7 INSTRUMENTATION AND CONTROLS

THIS NRC STAFF DRAFT SE HAS BEEN PREPARED AND IS BEING RELEASED TO SUPPORT INTERACTIONS WITH THE ACRS. THIS DRAFT SE HAS NOT BEEN SUBJECT TO FULL NRC MANAGEMENT AND LEGAL REVIEWS AND APPROVALS, AND ITS CONTENTS SHOULD NOT BE INTERPRETED AS OFFICIAL AGENCY POSITION.

This chapter of the safety evaluation report (SER) documents the U.S. Nuclear Regulatory Commission (NRC) staff's (hereinafter referred to as the NRC staff) review of Chapter 7, "Instrumentation and Controls," of the NuScale Power, LLC (hereinafter referred to as the applicant), Standard Design Approval Application (SDAA), Part 2, "Final Safety Analysis Report." The NRC staff's regulatory findings documented in this report are based on Revision 1 of the SDAA, dated October 31, 2023 (Agencywide Document Access and Management System (ADAMS), Accession Nos. ML23304A350 (Proprietary); ML23304A348 (Non-Proprietary)). The precise parameter values, as reviewed by the NRC staff in this safety evaluation (SE), are provided by the applicant in the SDAA using the English system of measure.

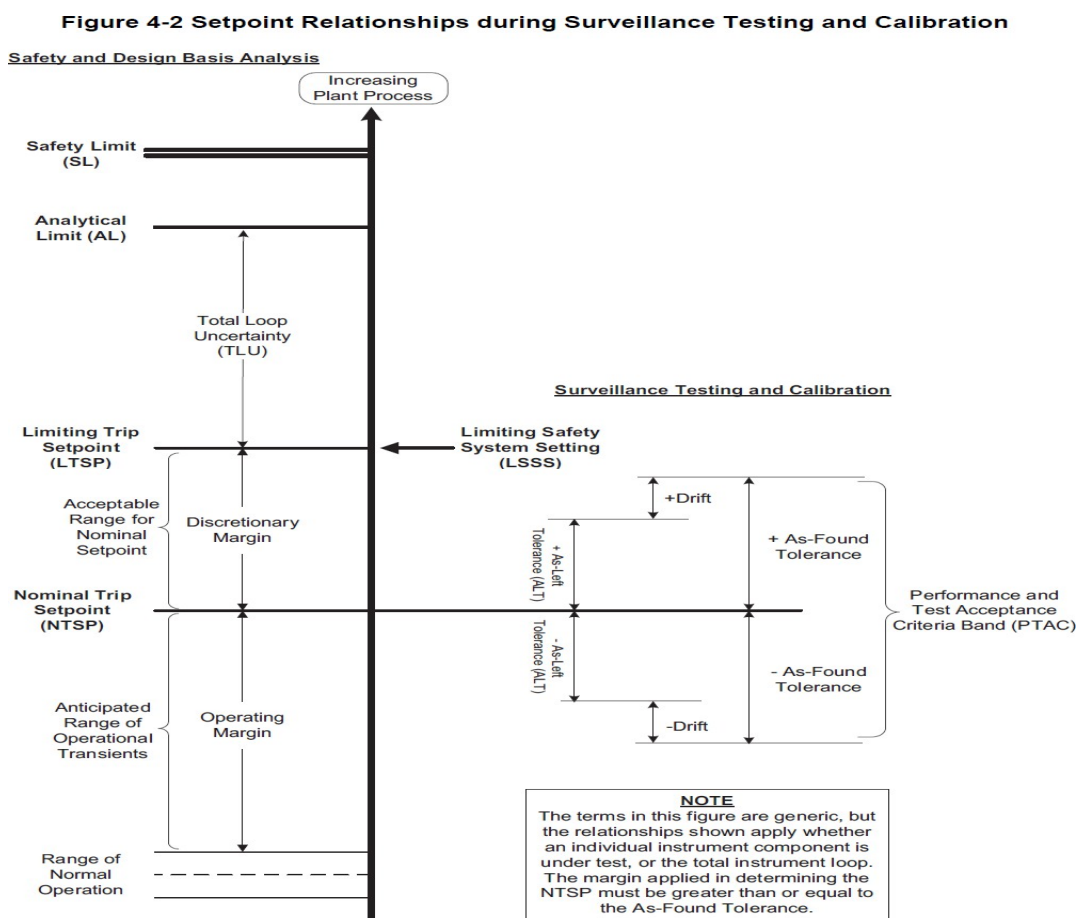
The NRC staff reviewed TR-122844P Figure 4-2, "Setpoint Relationships during Surveillance Testing and Calibration," and confirmed that the relationships of parameters as shown in TR-122844-P, Figure 4.2 below, are consistent with relationship parameters shown in Figure 1, "Relation Between Setpoint Parameters," of ANSI/ISA-67.04.01-2018 and conform to the guidance in RG 1.105, Revision 4.
